UN Regulation No. 51 (Noise of M and N categories of vehicles)**Proposal for Supplement 8 to the 03 series of amendments to
UN Regulation No. 51****Submitted by the Informal Working Group on Measurement
Uncertainties***

The text below has been prepared by the experts of the Informal Working Group on Measurement Uncertainties (IWG MU) in order to introduce measures to reduce variability. The modifications to the existing text of the UN Regulation are marked in bold for new or strikethrough for deleted characters.

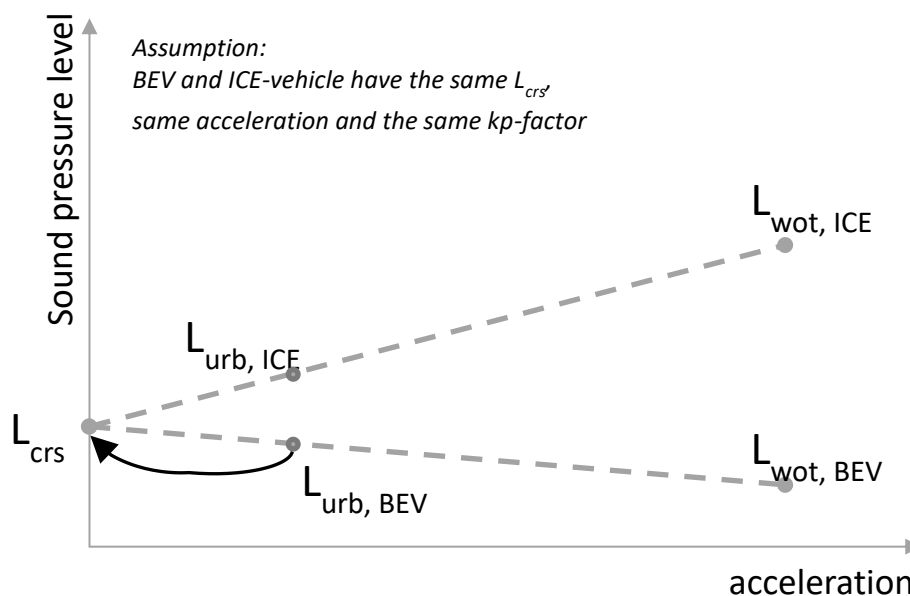
1. The temperature correction in Supplement 7 is based on the sound behavior of internal combustion engine (ICE) vehicles. Due to their powertrain noise, the sound emission in accelerating condition is always higher than in cruising condition.

2. For battery electric vehicles (BEVs) the dominant source is the tyre road noise. For this reason, the sound emission in cruising may be higher than during acceleration. In this case the current temperature correction will be inaccurate and cause an additional burden to the BEVs.

6. To avoid confusion due to a reported value of L_{urban} , which may be smaller than L_{crs} in this special case, L_{urban} is set to L_{crs} , as shown in the diagram below.

In cases where $L_{wot,rep}$ is less than $L_{crs,rep}$:

$$k_P=1$$

In the cases where $L_{wot,rep}$ is less than $L_{crs,rep}$ the final result L_{urban} is the result of the cruise test:

$$L_{urban} = L_{crs,rep}$$
